**SECTION 00 90 02
BIDDING AND CONTRACT REQUIREMENTS
ADDENDUM NUMBER 2**

Issued: May 5, 2026

**Fire Tower Replacement
Issued for Bid**

Architect's Project Number: 25-028

KEY PLAN:

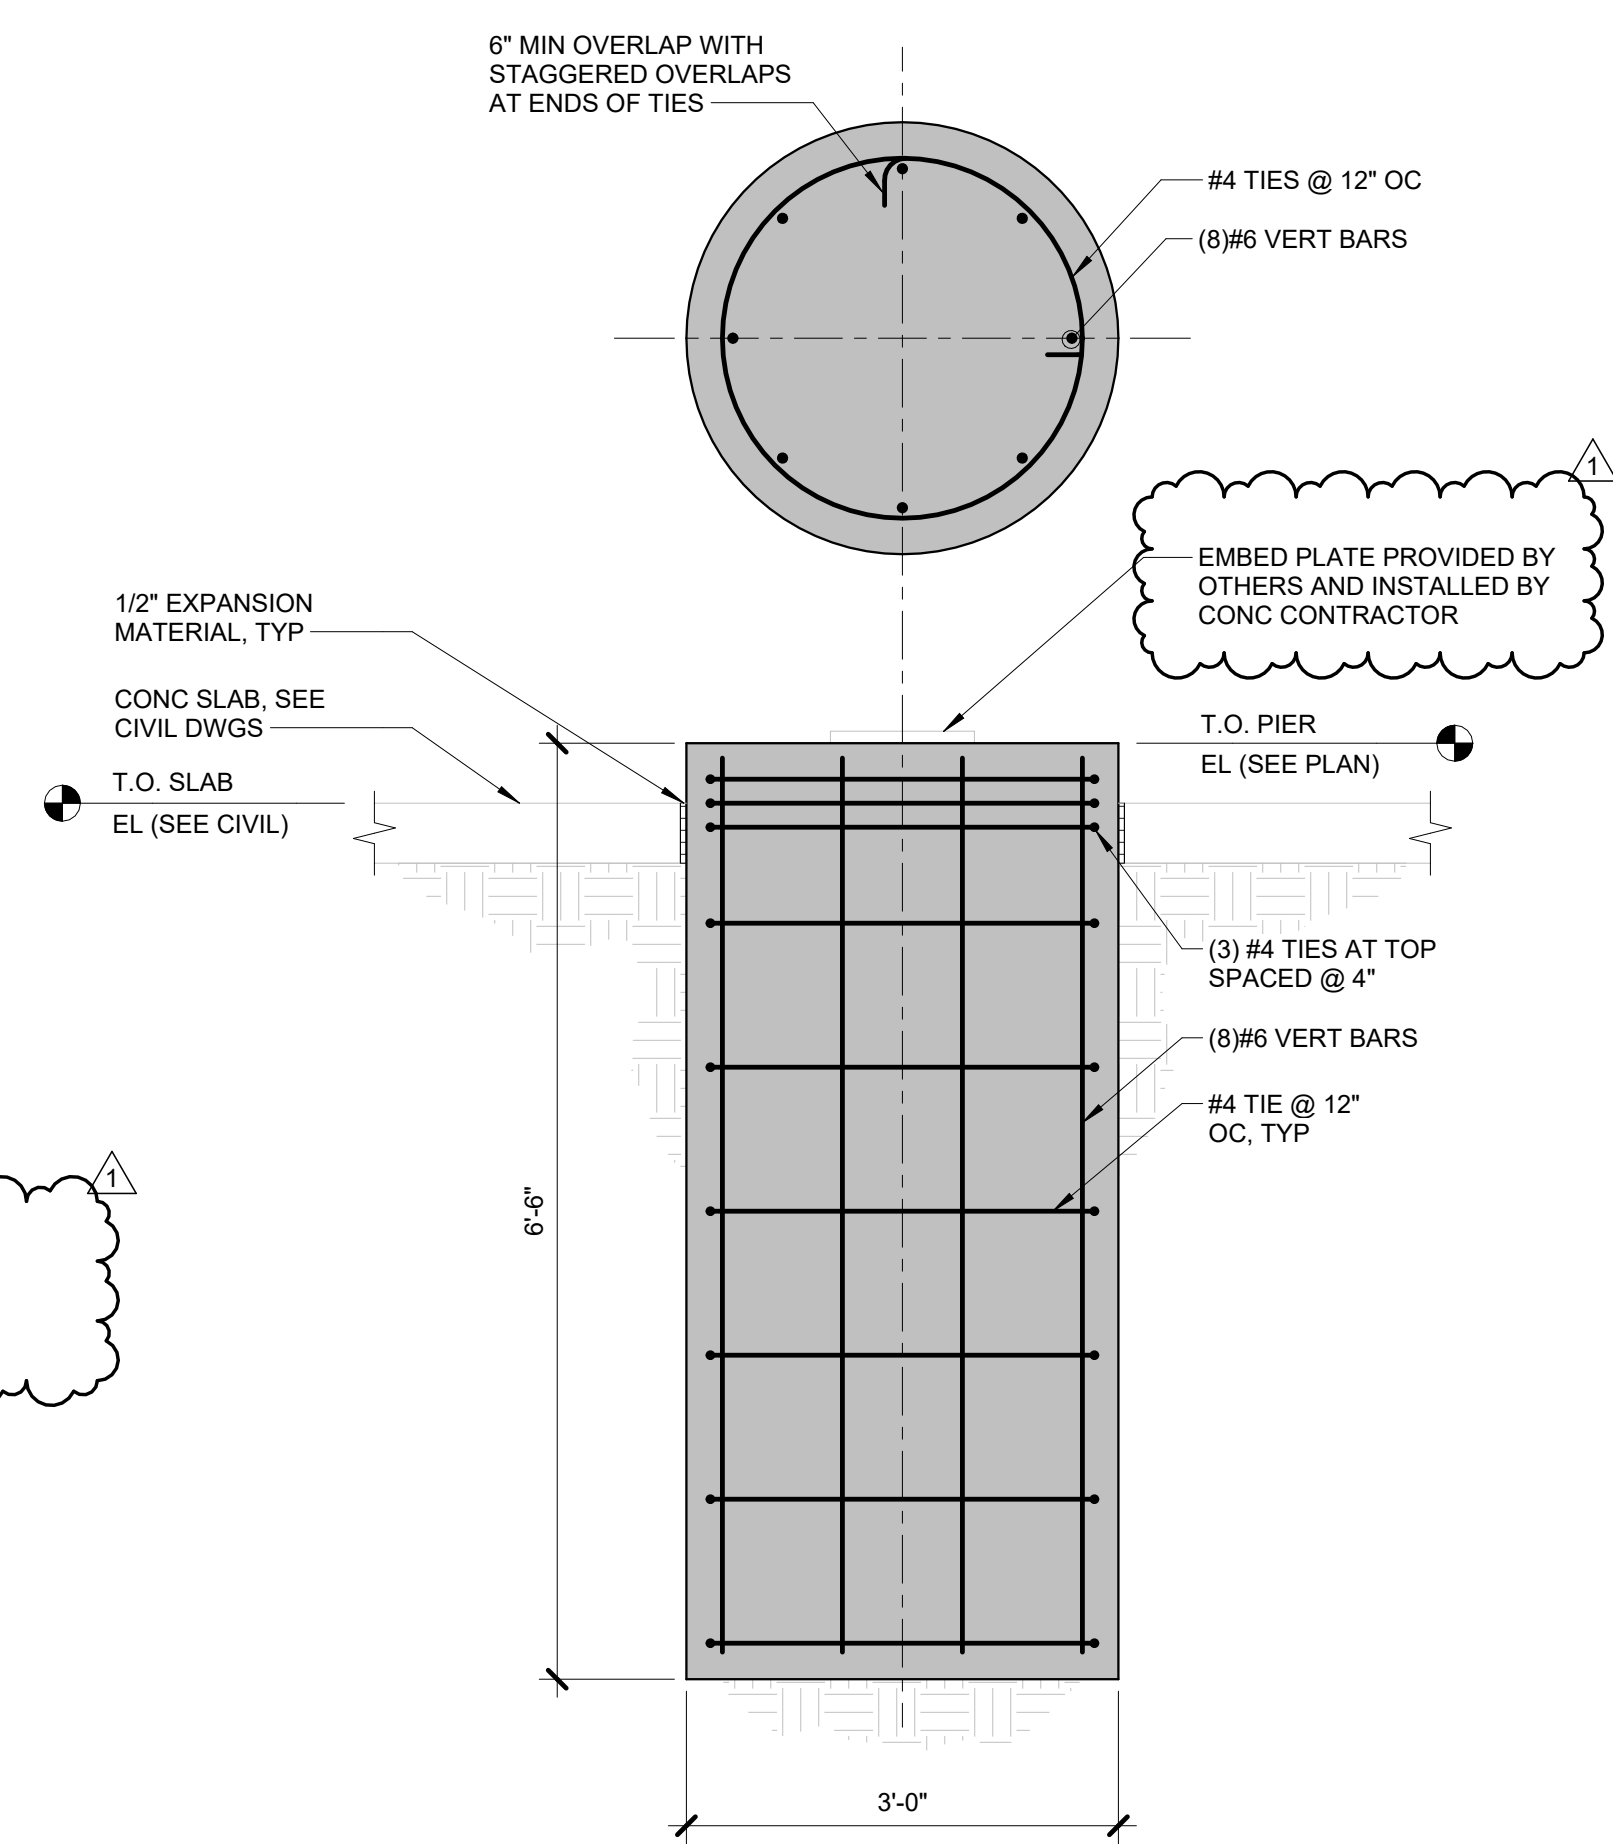
- A. **REVISE** embed plate notes in details 2 and 3 to clarify installation scope.
B. **REVISE** foundation plan column grids to show different grids at each building. Refer to civil drawings for each building location.
